# Upgrade Information of MPE720 Version 6

The add function and the improvement from MPE720 version 6.01 to MPE720 version 6.02 are as follows.

## No.1 Change of specification of system work (D register) in Ladder Editor

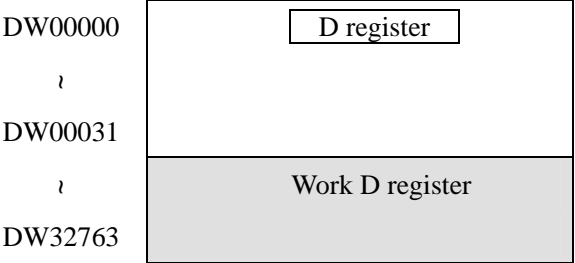
The current work D register was allotted in order of the previous address the user was a property screen from the end of specified D register number.   Therefore, work D register used D register address which the user used.

Work D register allotted from the following addresses of D register number which the user set, and prevented D register which the user used with the ladder in the program and the address the overlap.

**< Error display of cannot secure area of work D register >**

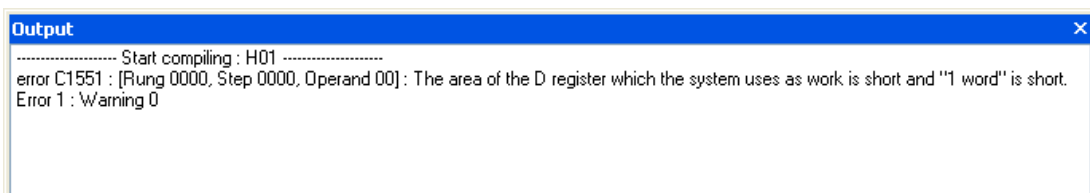
When the area of work D register cannot be secured when compiling, the error is displayed on the output screen.

## No.3 Add the register jump function of comment list

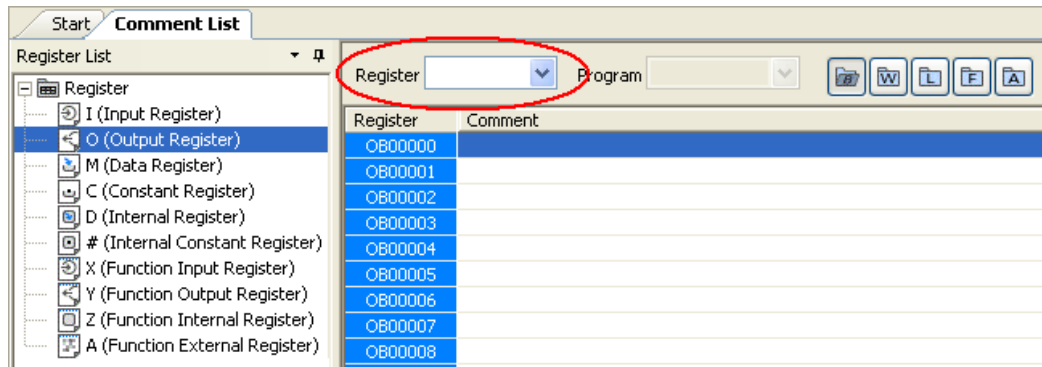
The register address was input to the column of the input of the register of the comment list, and the jump function, which moved to the corresponding register was added.

The register input column was added to the header.

When the register address is input to the column of the input of the address of the comment list, and clicks the Enter, it moves to the register of the correspondence.

## No.20 Communication Process: Extension of the number which simultaneously allocated by the serial port

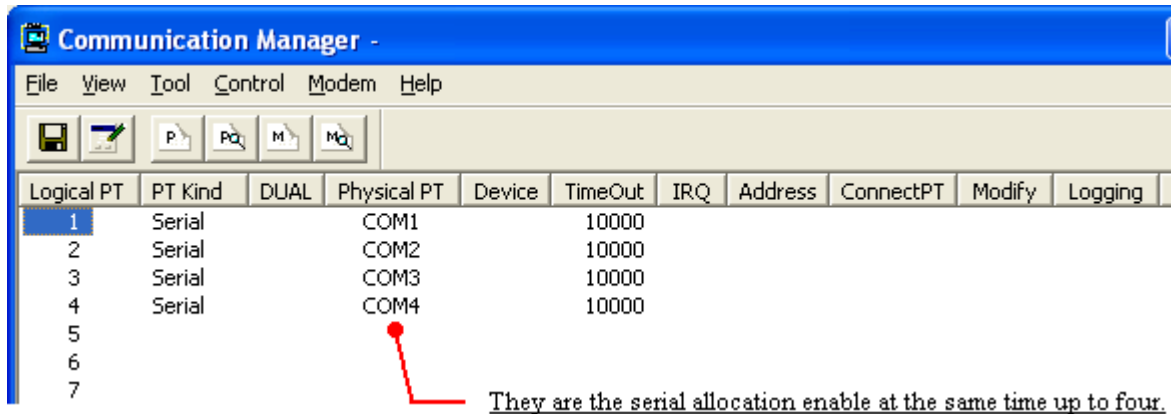
Serial ports can be allocated to the port of the Communication Manager only up to two at the same time up to now.   They were allocated up to four.

They are the serial allocation enable at the same time up to four.

## No.21 Communication Process: Extended COM port number

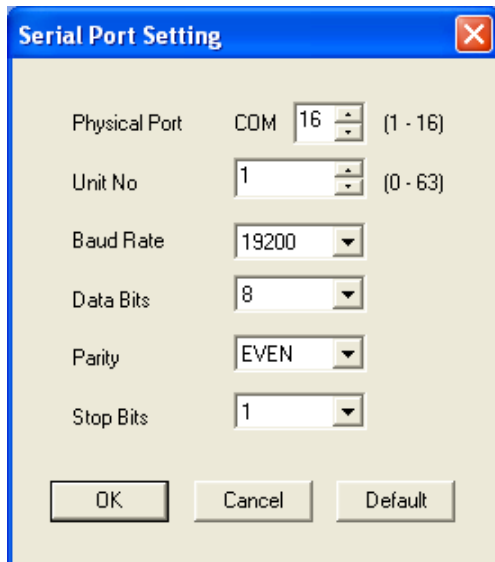
The use of the USB -> Serial converter cable becomes an enable, and the number of COM ports increases.   Therefore, number of COM port which was able to be used when the serial port of the communication manager was set was made to be able to be set up to 16.

## No.32 Unusable "Compile to version 5 compatible" before version 5.34

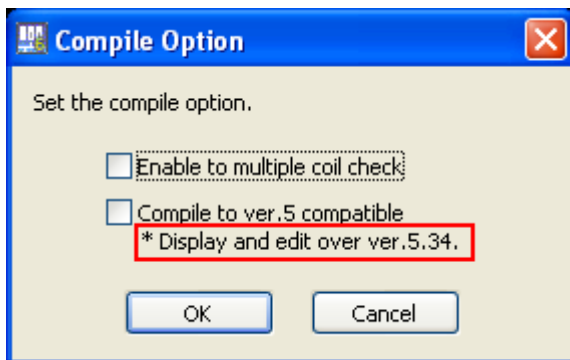
The program of compile to version 5 compatible cannot be opened by older version than MPE720 version 5.34.   The program of compile to version 5 compatible assumed, and described this clearly on the compilation option screen as the use since MPE720 version 5.34.

### No.42 Display of confirmation message when all comment list is cleared

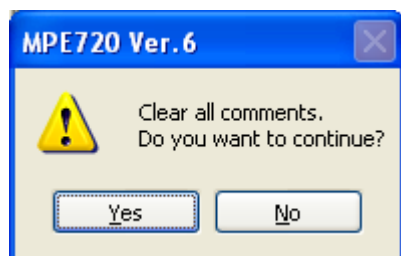
The confirmation message was displayed by the comment list at "Clear all comments".
